Dwelling type:	House and Garage.
Dwelling configuration:	Single Storey.
Nature of works:	New Building.
Stage of inspection:	Frame.
Construction Type:	Brick Veneer.
Garage:	Attached.
Foundations:	Slab.
Builder:

Schedule of Defects:

Defects, observations and other related comments from the Frame Inspection on the 20/04/2021:

Figure 3.1.3.2 Site surface drainage

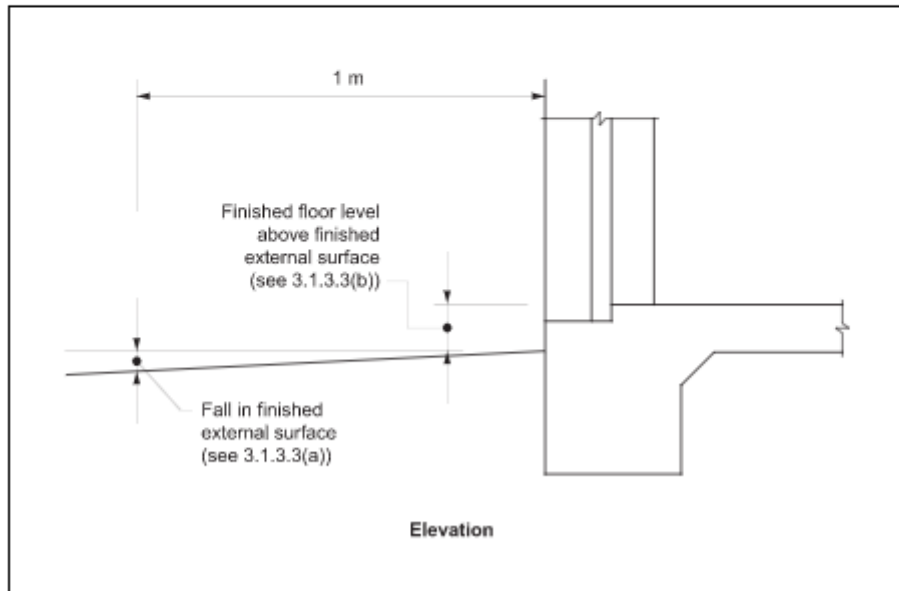
The dwellings slab footings have the opportunity to pool with water due to the way the block has been cut and the lack of back filling.

The NCC is very clear in its requirements to have the soil graded from the start away from the dwelling as a minimum of 50 mm over 1 m. This has not been done. We refer all to the NCC, part 3.1.3.3.

We also refer the builder to the soil report and engineering drawings that clearly call for the site drainage to be managed via sloping water away from the slab and more so, managing same.

FIGURE 4.22 END FIXING DETAILS AT HEEL—TO TOP PLATE

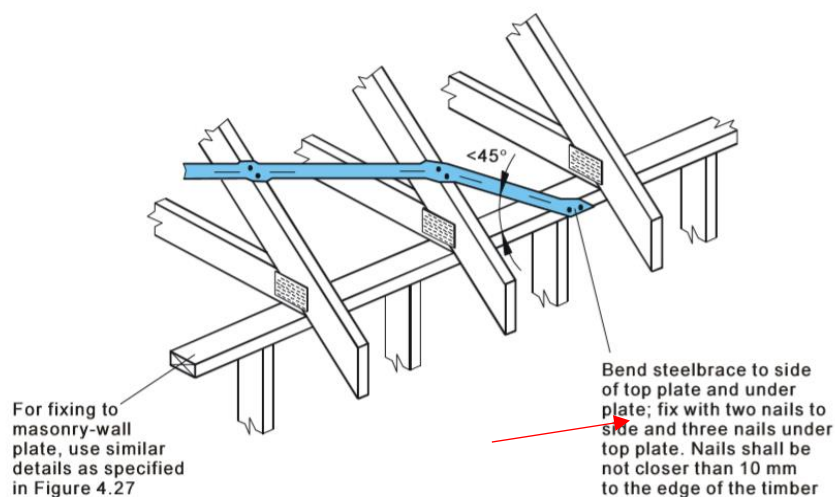
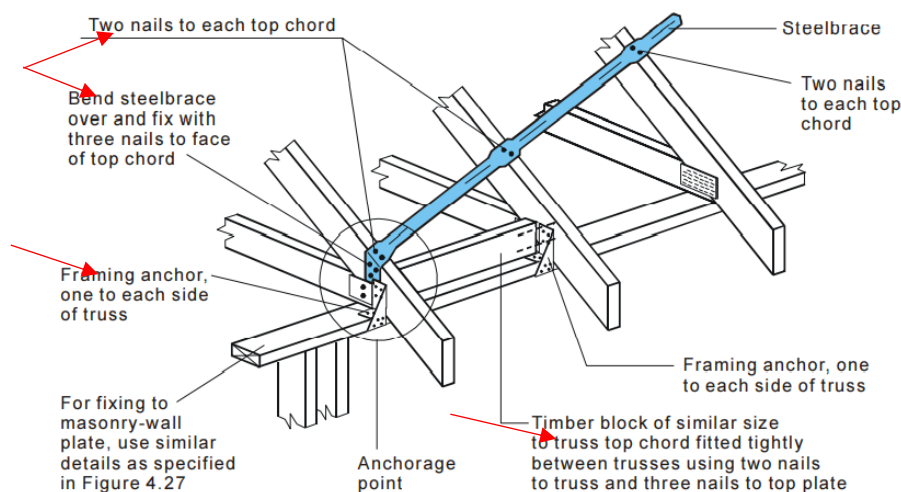
AS 4440; clause 4.3.8(c) and Pryda Installation Guide: - Diagonal steel roof braces (speed brace) shall be fixed to the top plate in accordance with one of the following methods.

The roof frame speed brace has not met this requirement.

Not fixed.

Extra nailing required, check all.

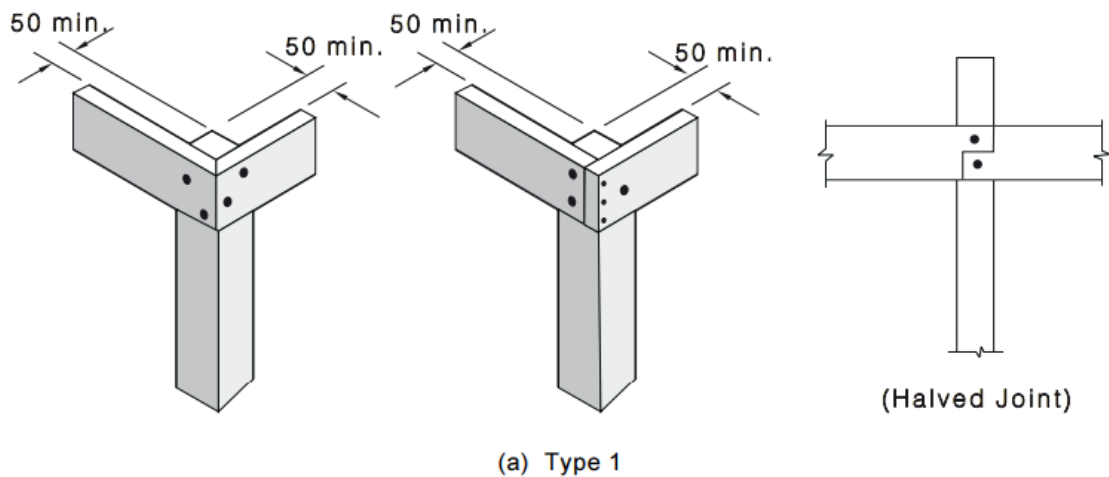
AS 1684.2; 9.2.9, Figure 9.3(a): - Posts supporting members at joints shall have a minimum amount of 50mm retained at the post to adequately resist uplift.

Timber posts have not met this requirement.

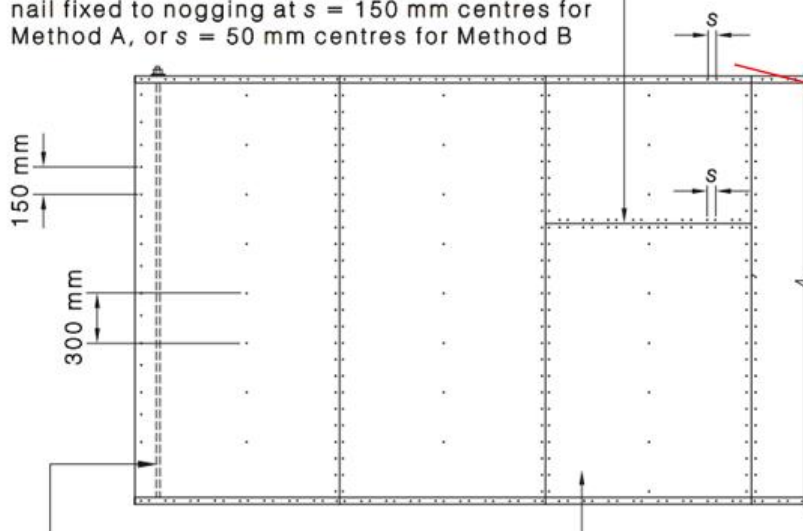
AS 1684.2; Table 8.18: - The sheet bracing shall be installed using 30 x 2.8 mm diameter galvanised flat head nails at the required spacings given in the table below. Many of the nails have been over driven or over shot below the surface of the bracing ply. Overshot nails have compromised the bracing sheets ability to resist racking forces. Also note the minimum sheet thicknesses given below.

Bracing panels with over shot nails have not met these requirements.

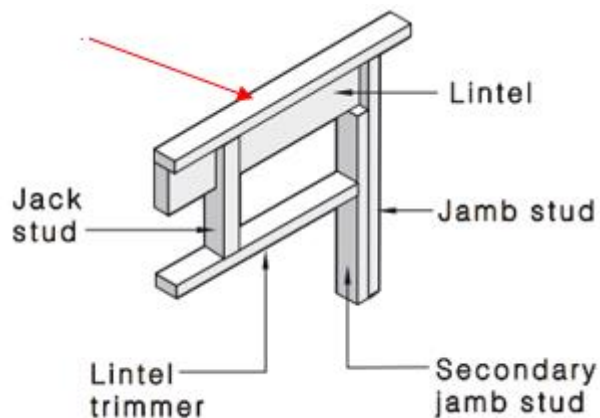
AS 1684.2; 6.3.6.1: - In timber wall framing, top plates shall be provided above lintels.

This requirement has not been met.

FIGURE 6.6 NOGGING

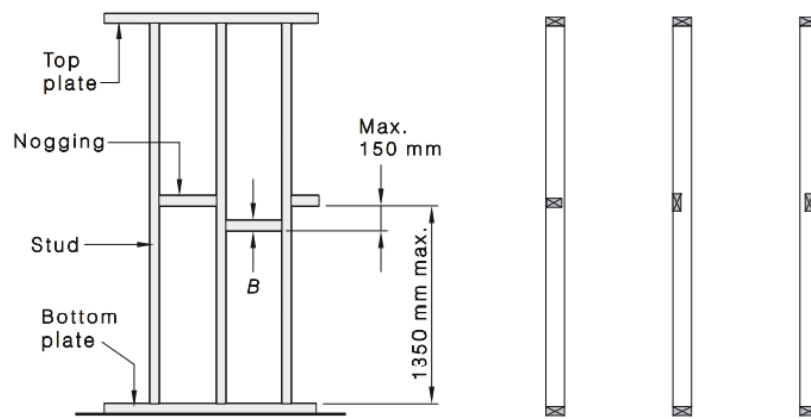
AS 1684.2; 6.2.1.5: - Wall studs shall have continuous rows of noggings at 1350 mm maximum centres.

Breaks in the continuity of the nogging row through either short or missed nogging means that this requirement has not been met.

FIGURE 2.3 FIXING OF TRUSSES TO FREESTANDING NON-LOADBEARING WALL THAT IS NOT A BRACING WALL

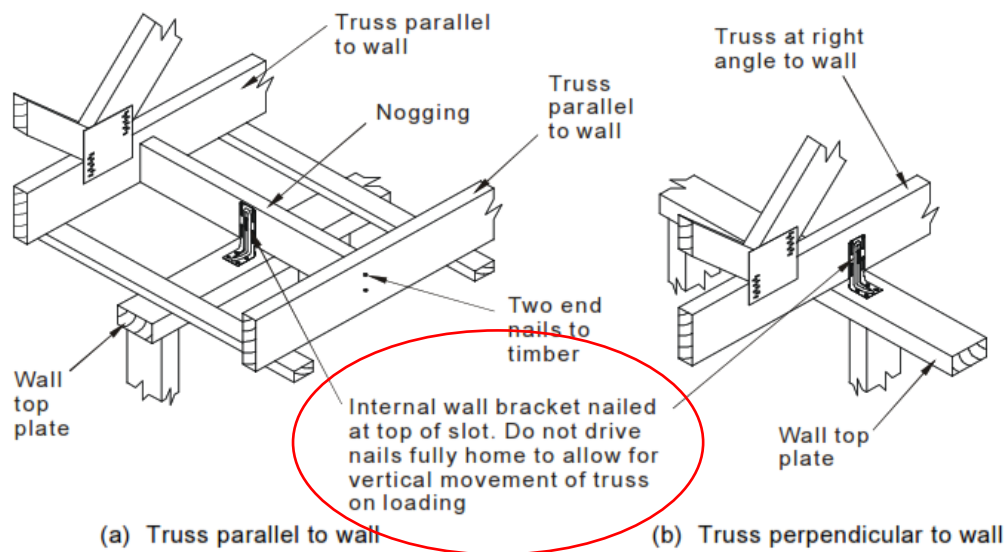
AS 4440; 2.2.3(c), Figure 2.3: - “Do not drive (‘L’ bracket) nails fully home to allow for vertical movement of truss on loading.”

Nails have been driven home hard to the bracket slots. Hence this requirement has not been met.

Check all.

FIGURE 9.2 JOINING OF TOP PLATES AND RING BEAMS

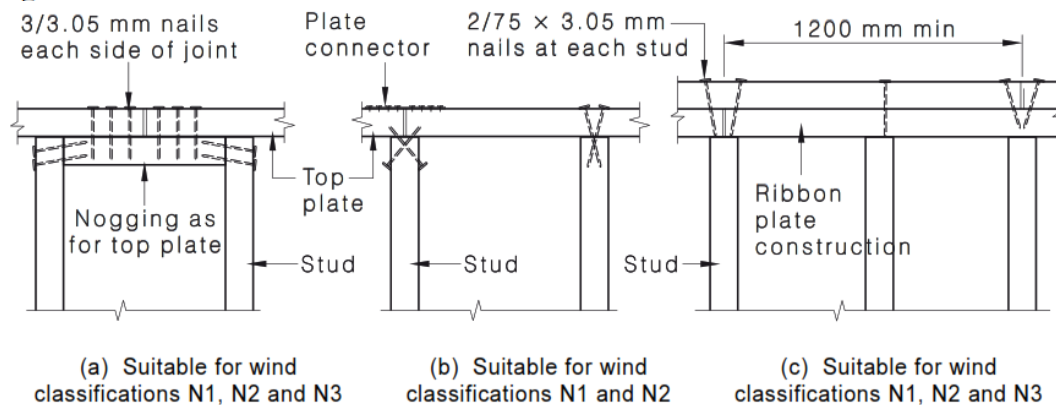
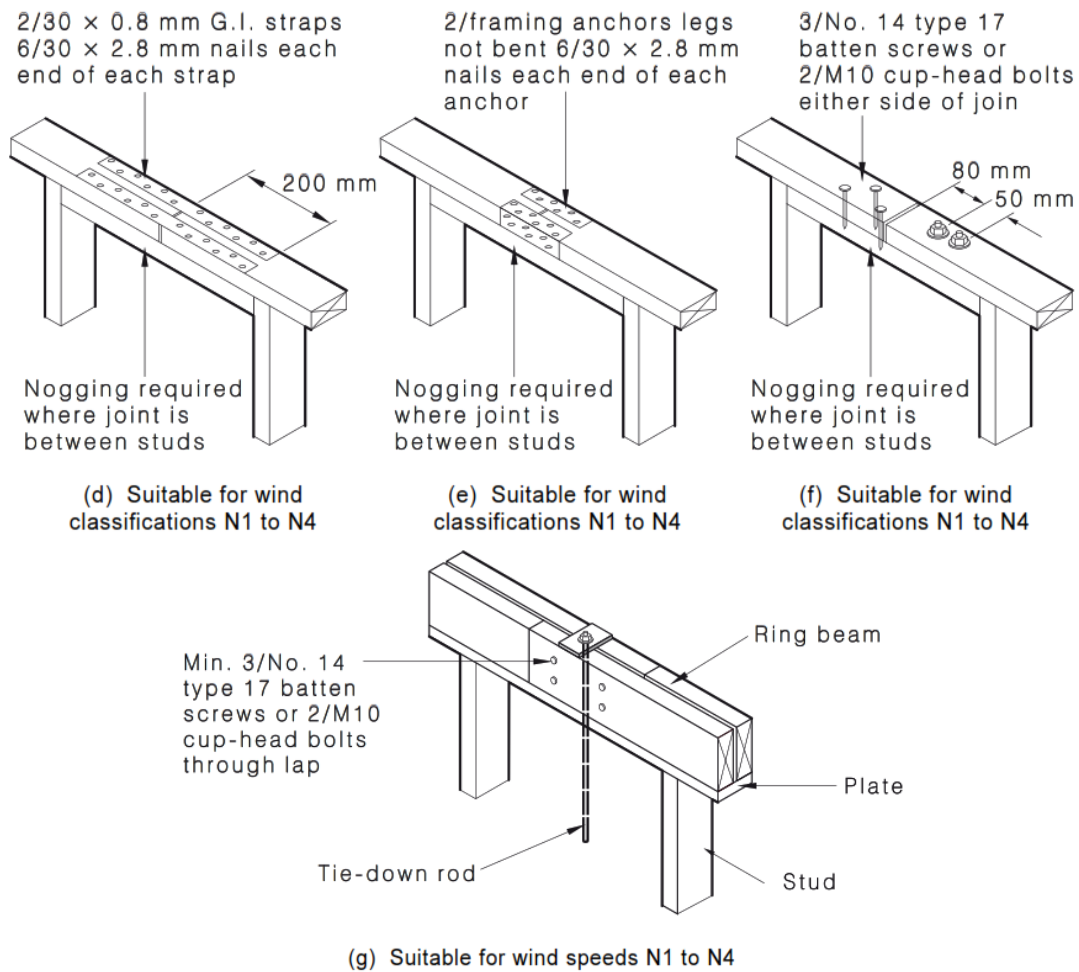
AS 1684.2; 9.2.8: - calls for the installation of a plate connector (gang nail plate or equiv.) at the top of all intersecting walls. Where plates interlock, they are not required.

There are gang nails missing to several of the top plates to the wall's connections. These plates play a vital role in securing one wall to another. It also assists with the racking force resistance on a home.

In areas, top plate connections have not met this requirement.

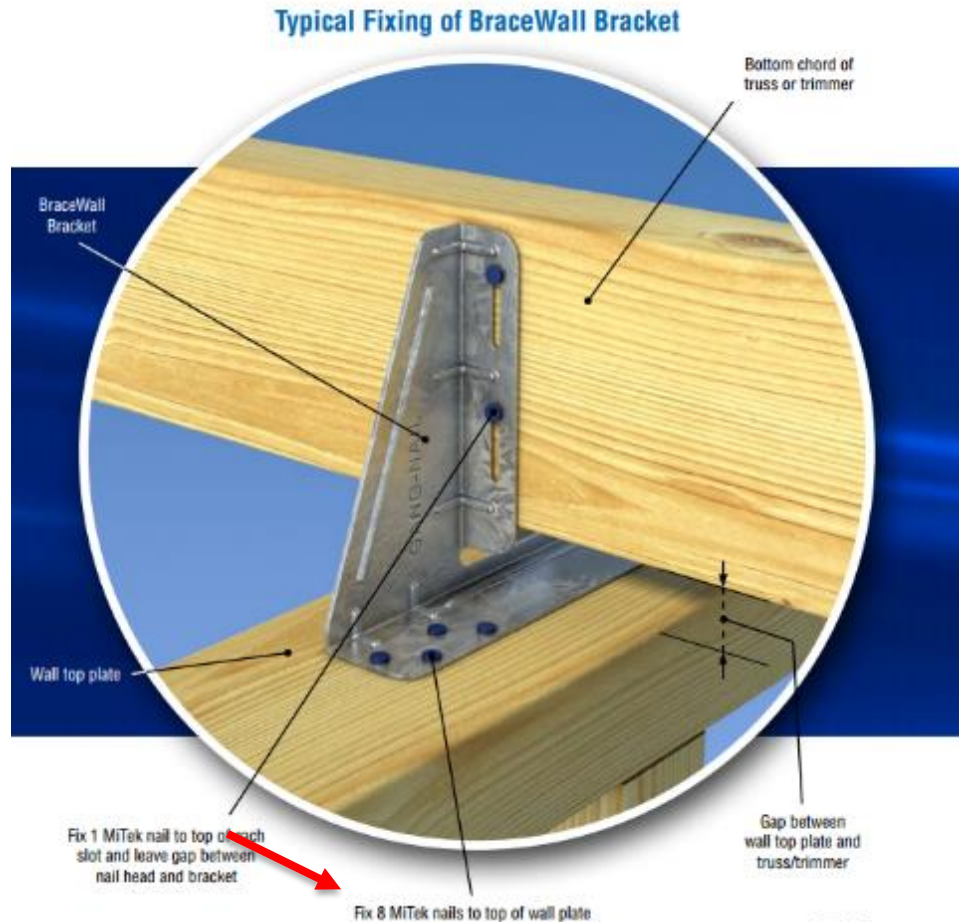
AS 1684.2; 6.3.3: - Where bottom plates support studs supporting concentrated loads, posts or jamb studs, the plate shall be supported over a floor joist, solid blocking between bottom plate and bearer or concrete slab.

The bottom plate requires solid blocking / packing in the areas indicated to satisfy this requirement.

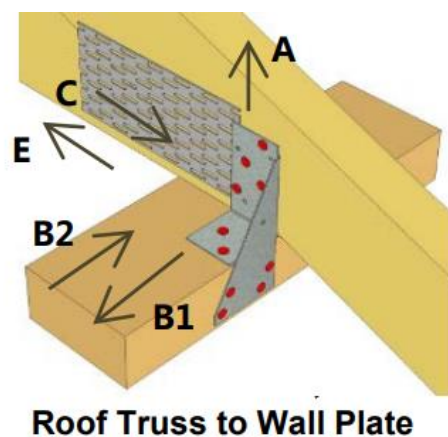
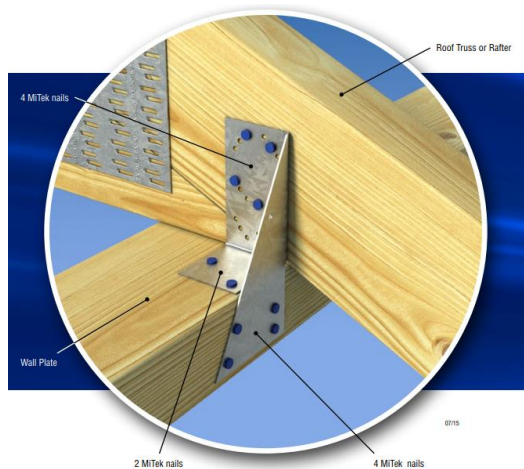
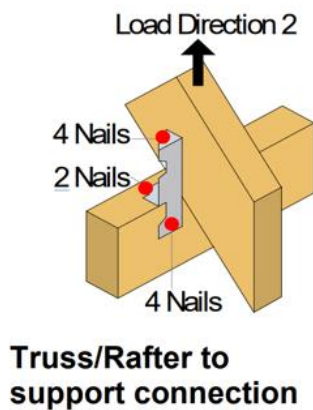
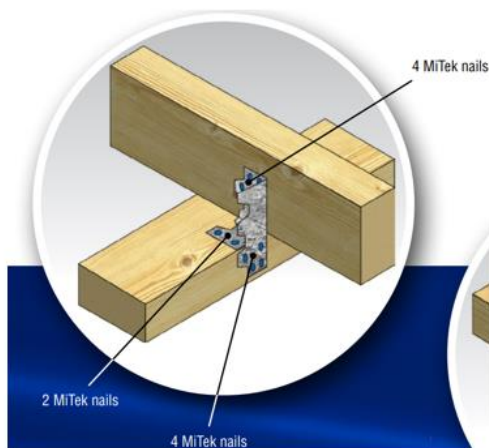
Pryda and Mitek; Triple Grip & Multigrip installation: - Both manufacturers of triple grips and multigrips require 10 hot dipped galvanised reinforced head nails installed in the following configuration when attaching to rafters and trusses. The current installation has not met the manufacturer's requirements.

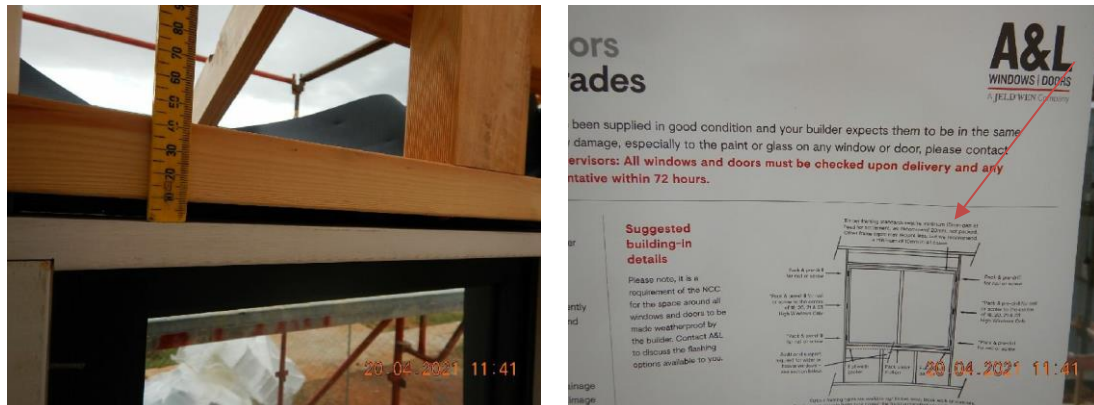
AS 1684.2; 6.2.3: - 15mm minimum shall be provided between top of window or door frames and underside of lintel / frame head.

There are openings to this dwelling have not met this requirement.
